Packaging Change Notification

■ Product List Business430-19008_DF12 Series Packaging specification change

■Details of change_DF12 Series Packaging specification change

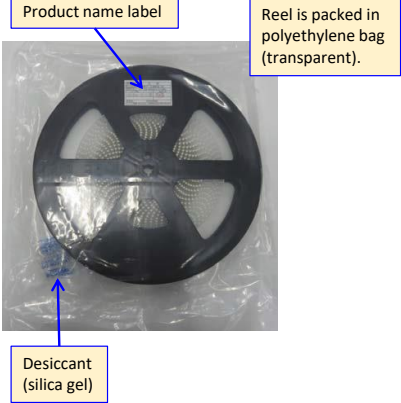
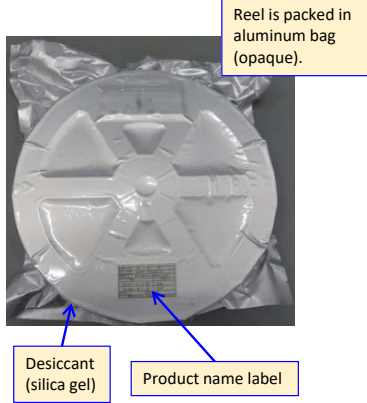
Before Change Polyethylene bag packing	After Change Aluminum bag deaeration packaging
 <p data-bbox="292 283 454 315">Product name label</p> <p data-bbox="527 283 682 357">Reel is packed in polyethylene bag (transparent).</p> <p data-bbox="292 630 389 682">Desiccant (silica gel)</p>	 <p data-bbox="974 283 1120 357">Reel is packed in aluminum bag (opaque).</p> <p data-bbox="763 630 860 682">Desiccant (silica gel)</p> <p data-bbox="885 640 1047 672">Product name label</p>
<p data-bbox="332 730 609 756">Inside of Polyethylene bag packing</p>	<p data-bbox="738 730 1104 756">Inside of Aluminum bag deaeration packaging</p>
 <p data-bbox="349 787 511 819">Product name label</p> <p data-bbox="243 1165 552 1207">The reel is packed in a polyethylene bag with silica gel Only the product label is attached to the reel</p>	 <p data-bbox="828 787 990 819">Product name label</p> <p data-bbox="820 1113 982 1144">Humidity Indicator</p> <p data-bbox="706 1165 1096 1207">The reel is packed in an aluminum bag with silica gel and deaerated. Product label and humidity indicator are attached</p>
